Fourth Five-Year Review Report for Colbert Landfill Spokane County, Washington

September 2009

**United States Environmental Protection Agency
Region 10
Seattle, Washington**

Figure 16. Upper Aquifer, January 2004 Groundwater Elevation Contours

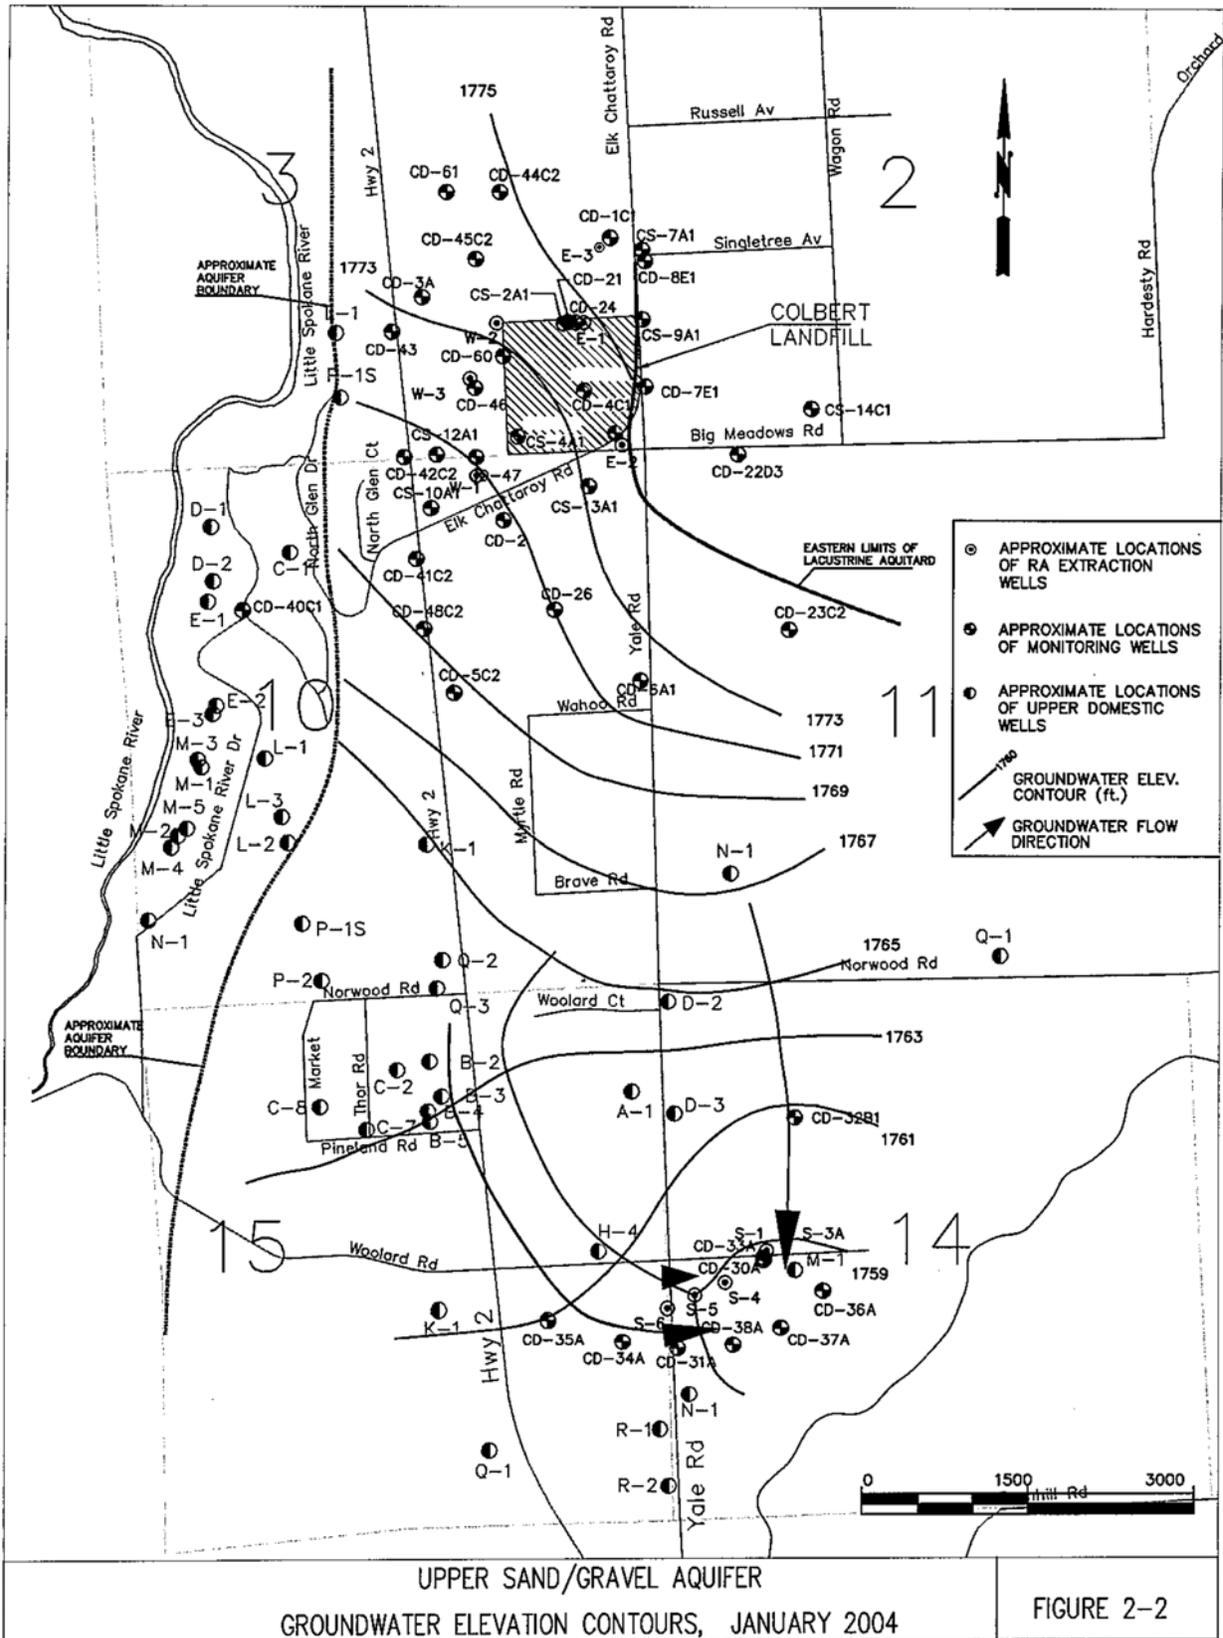
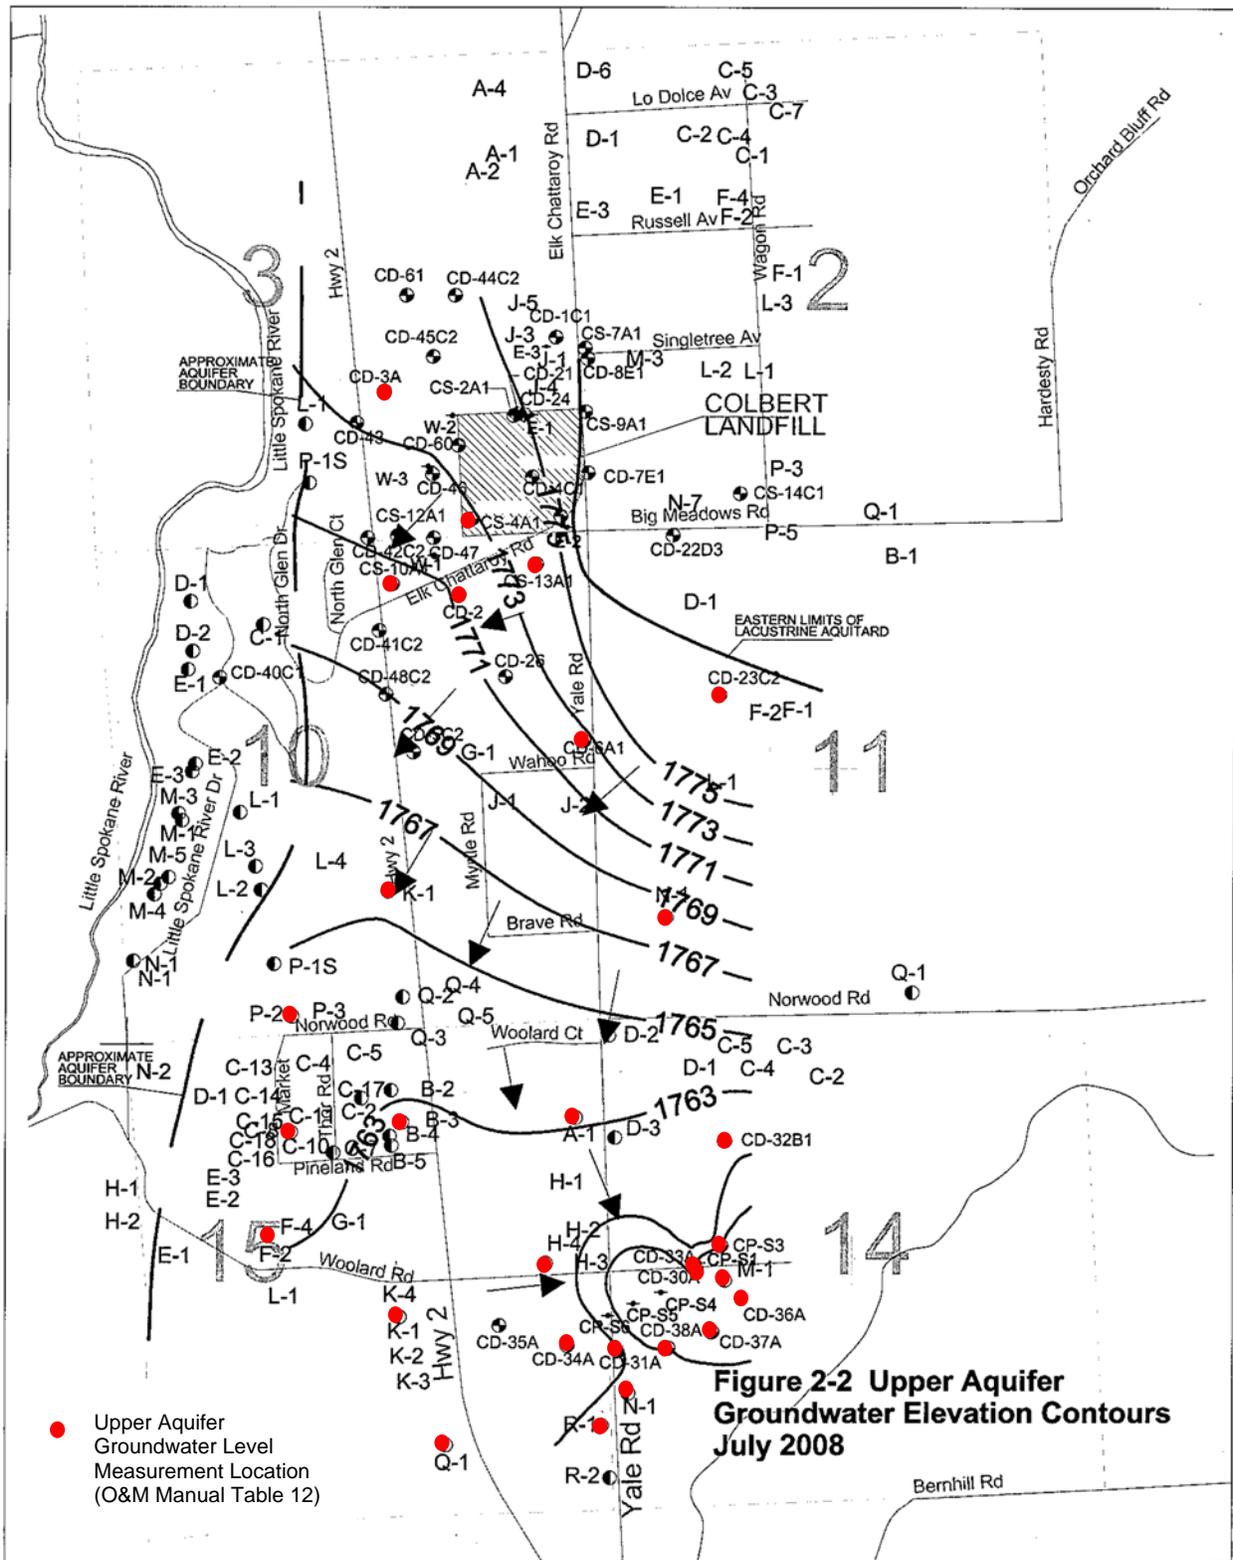
Figures 16 and 17 show the groundwater contours in the upper aquifer when the system was in operation (January 2004) and the most recent data (July 2008). The July 2008 groundwater contour map indicates that flow in the upper aquifer continues to be influenced by the south interception system even though it has been turned off since 2004. Since data are not presented on the maps, it is difficult to determine if this is caused by an erroneous measurement (such as the domestic well use drawdown) or is an on-going feature. Future quarterly reports should present the locations and data used to create the maps either directly on the groundwater flow maps or in a table.

3. Collect groundwater elevation measurements east of Elk Chattaroy/Yale Road. Include locations and measurements on groundwater flow maps or in a table to allow an accurate assessment of the flow line analysis.

Figure 22. Average Flow Rates for East System Extraction Wells

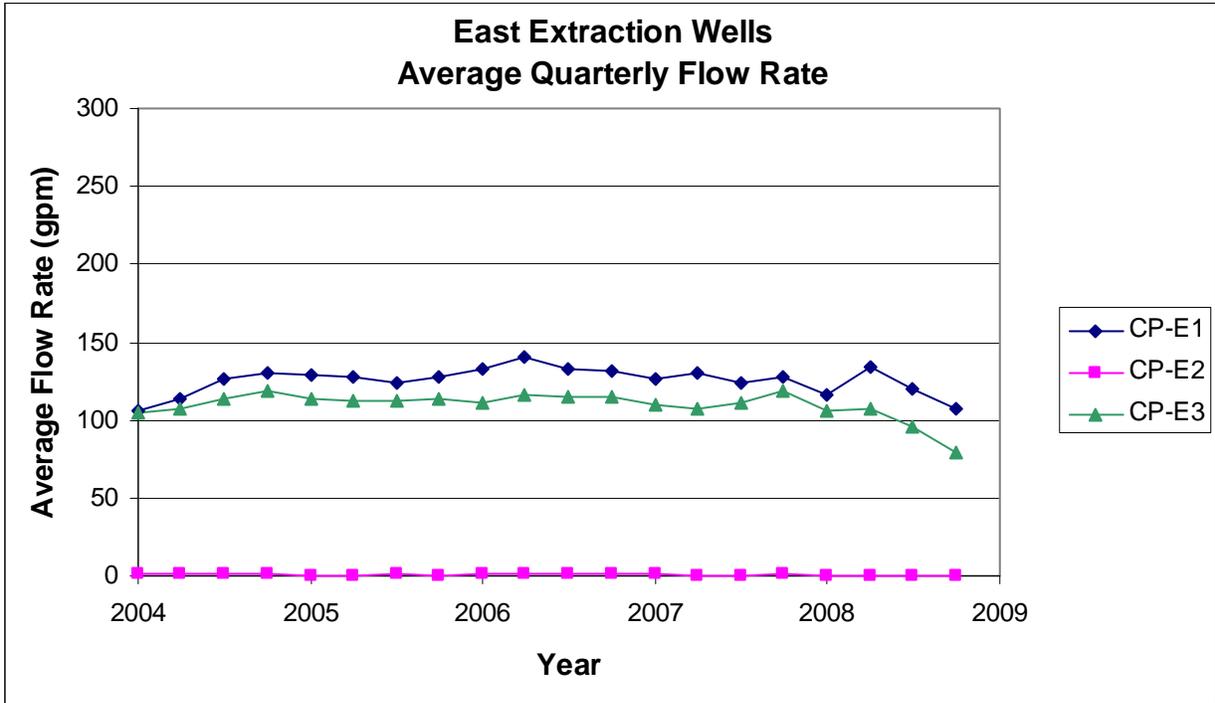
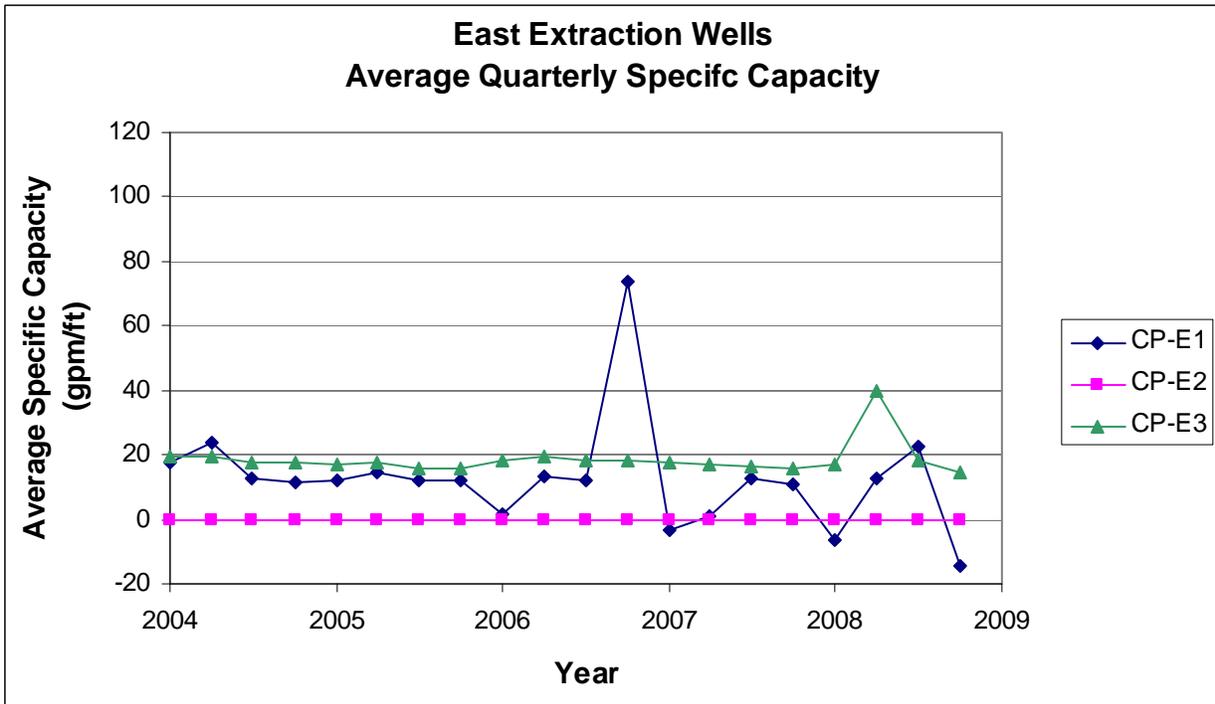
The east system (source contaminant control) consists of three extraction wells: CP-E1, CP-E2, and CP-E3. Average quarterly flow rates and specific capacity are shown on Figure 22 and 23, respectively. Flow rates and specific capacity data have been relatively steady for CP-E1 and CP-E3. Average specific capacity data at CP-E1 became highly variable between 2006 and 2009. This could be typical patterns associated with of downtime and equipment errors rather than a loss of well efficiency and will be further evaluated during the RSE. As discussed above, CP-E2 typically contains the highest concentrations of COC but has the lowest extraction rates. Since CP-E2 was completed in the basalt unit, which has low transmissivity, slow recharge, and is governed by fractured flow, contaminant removal rates are much lower. Typically, the contribution of CP-E2 to the overall mass removal of the extraction system is less than 1 percent. The continued operation of this extraction well in its current state and its effectiveness on the overall source removal rates should be evaluated. Potential remedies include replacement, pulse pumping, or shutdown.

4. Evaluate need for continued operation of CP-E2 in its current condition.
5. Include supplemental sampling in the groundwater monitoring program for the Site. Update the O&M Manual as necessary.

Figure 25. PCE concentrations detected in Lower Aquifer during Supplemental Sampling

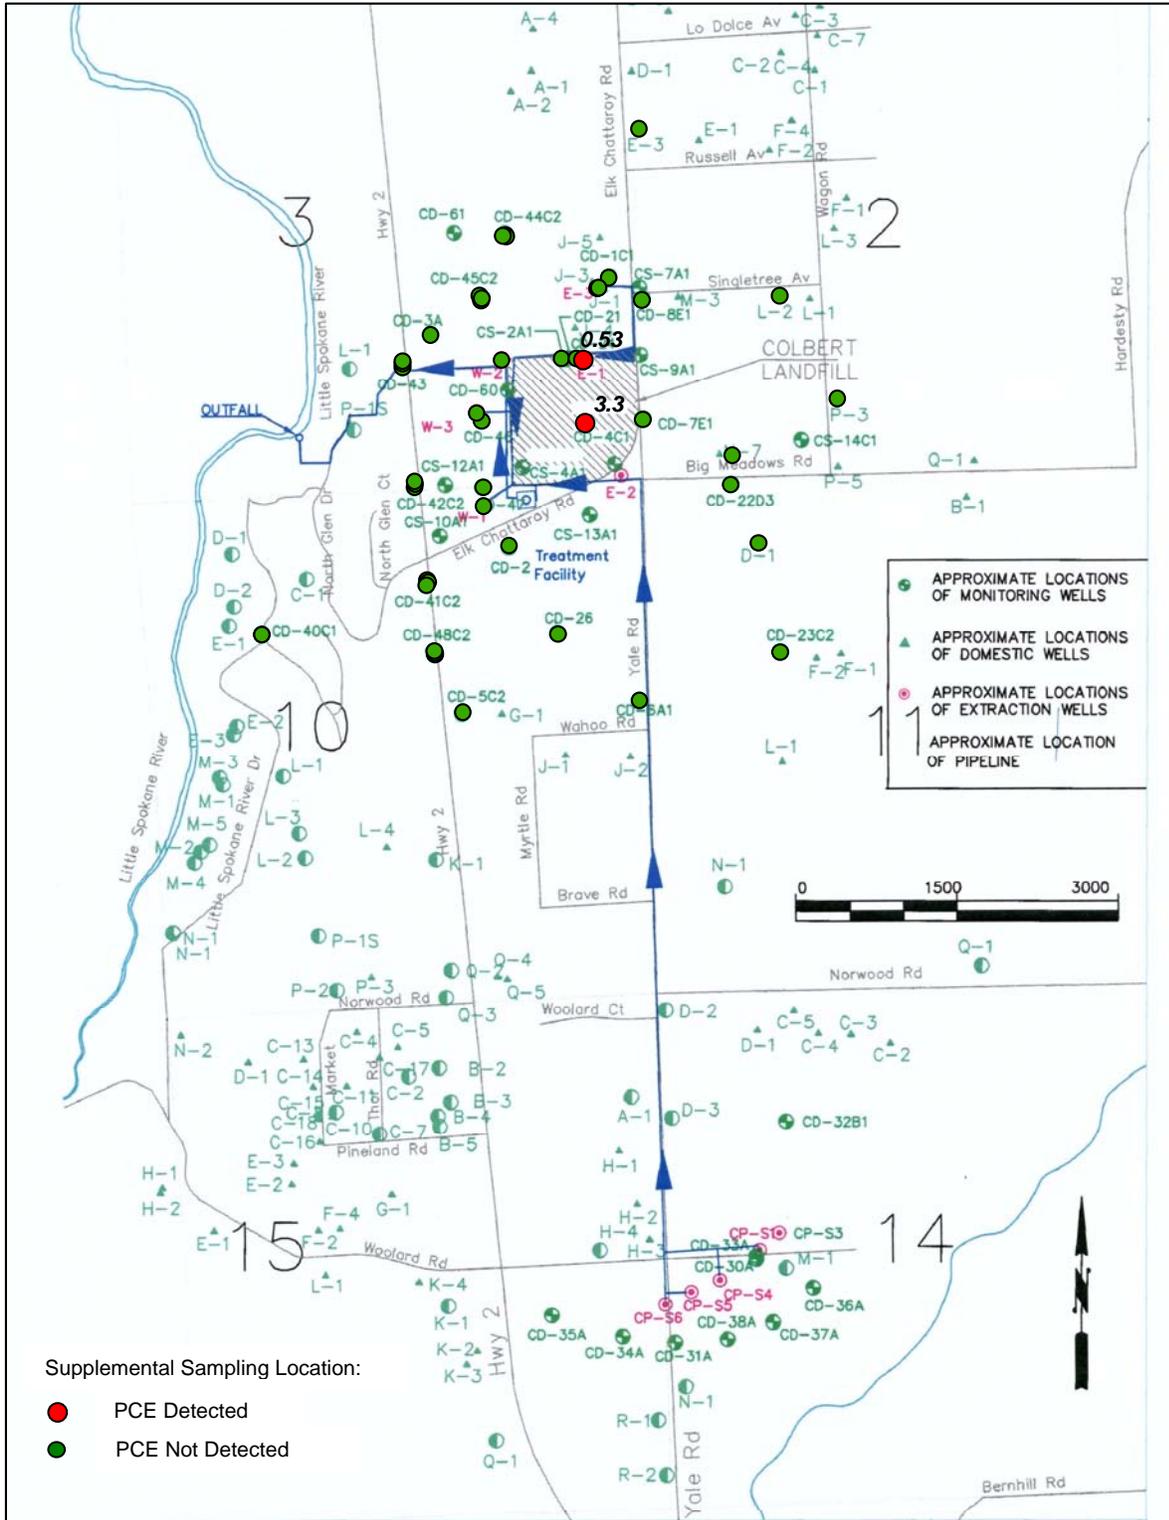
For the lower aquifer, the 2007 data indicate that 1,1-DCE, PCE, and TCE concentrations above performance criteria remain near the Landfill. Figure 25 shows that detected PCE concentrations in the lower aquifer are limited to the immediate Landfill area. Figure 26 and 27 show that 1,1-DCE and TCE, respectively, are still detected in the lower aquifer surrounding the landfill to the north, east, and south. Extraction wells are located near areas of contamination remaining to the north and east of the Landfill. According to the groundwater flow maps presented in the quarterly reports, groundwater in the area to the

Figure 29. 1,4-Dioxane Sampling Locations

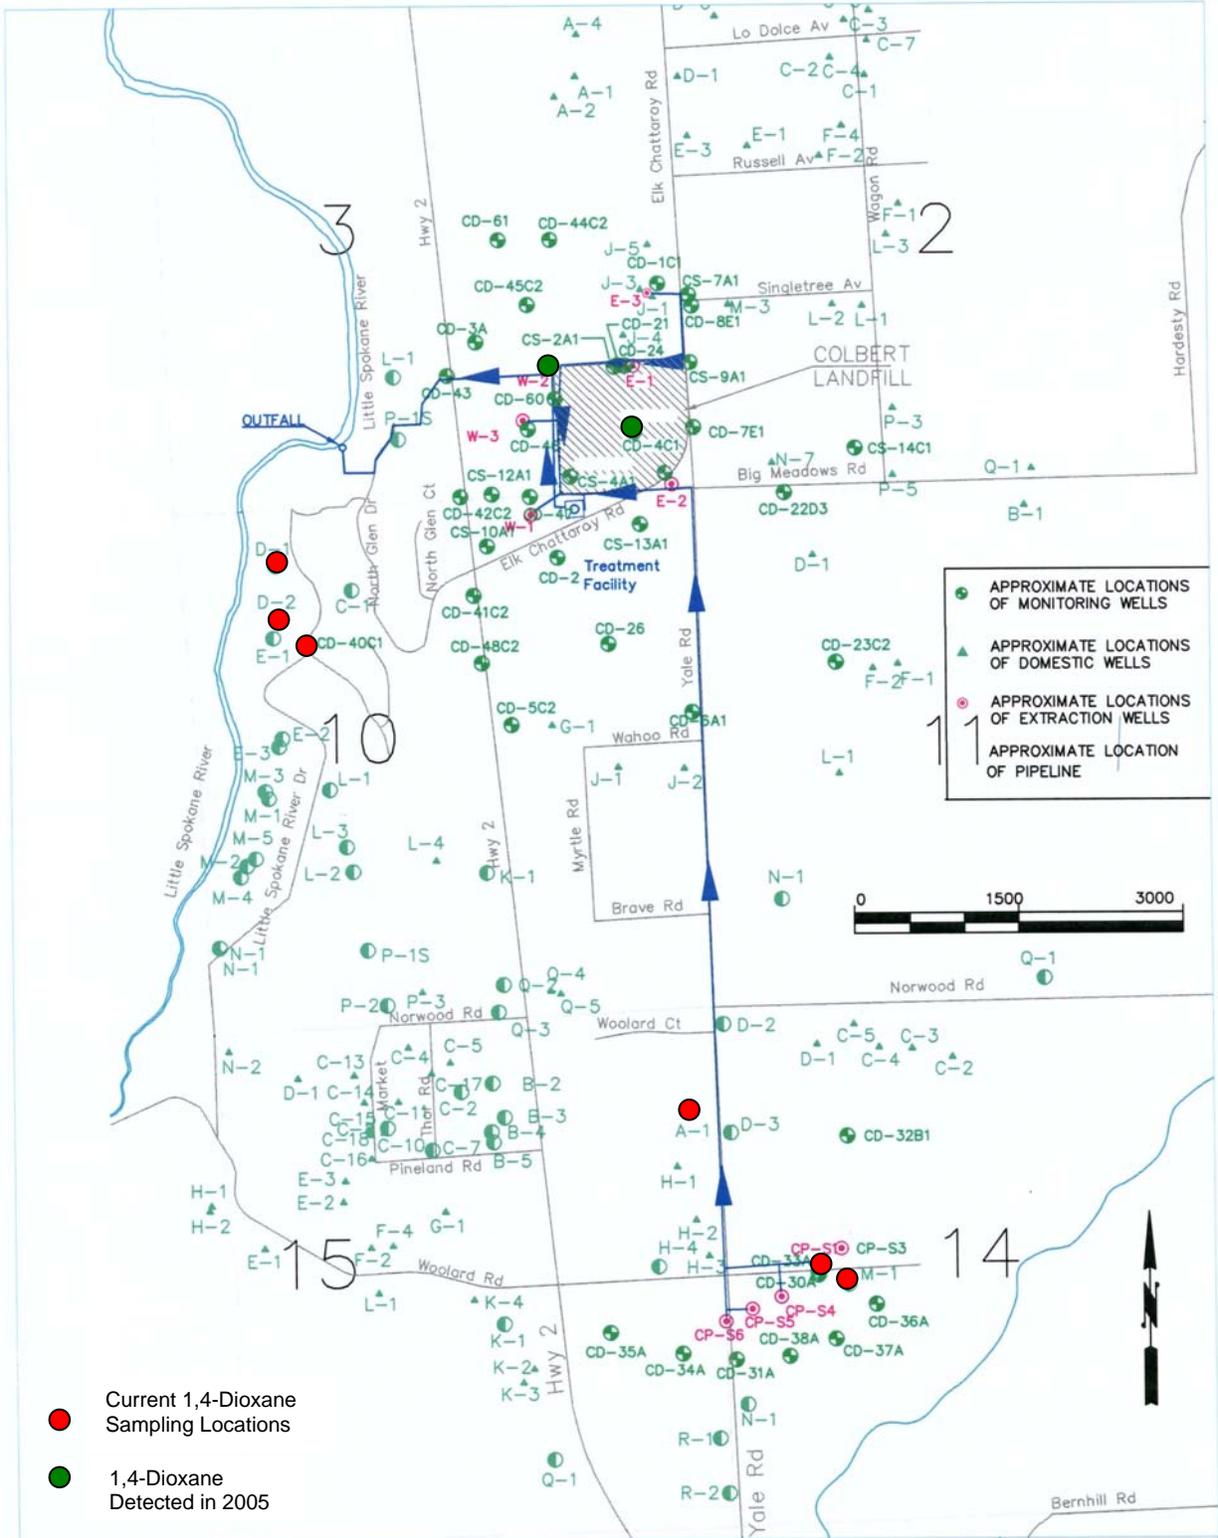
are shown on Figure 29: at the landfill (CP-W2 and CD-04C1/E1), in the upper aquifer near the Little Spokane River (1073D-1, 1073D-2, CD-40C1/2), and in the upper aquifer near the south interception system (CP-S1, 1573A-1, and 1473M-1). The County is currently collecting quarterly samples at the well locations near the Little Spokane River (1073D-1, 1073D-2, CD-40C1) and near the south interception system (1573A-1, 1473M-1, and CP-S1).

6. Continue sampling CD-40C1 on an annual basis and update the O&M Manual to include this location.
7. Evaluate 1,4-dioxane data at the completion of 4 quarters of monitoring. Include sampling of wells with concentrations of 1,4-dioxane above cleanup criteria in long-term monitoring program.
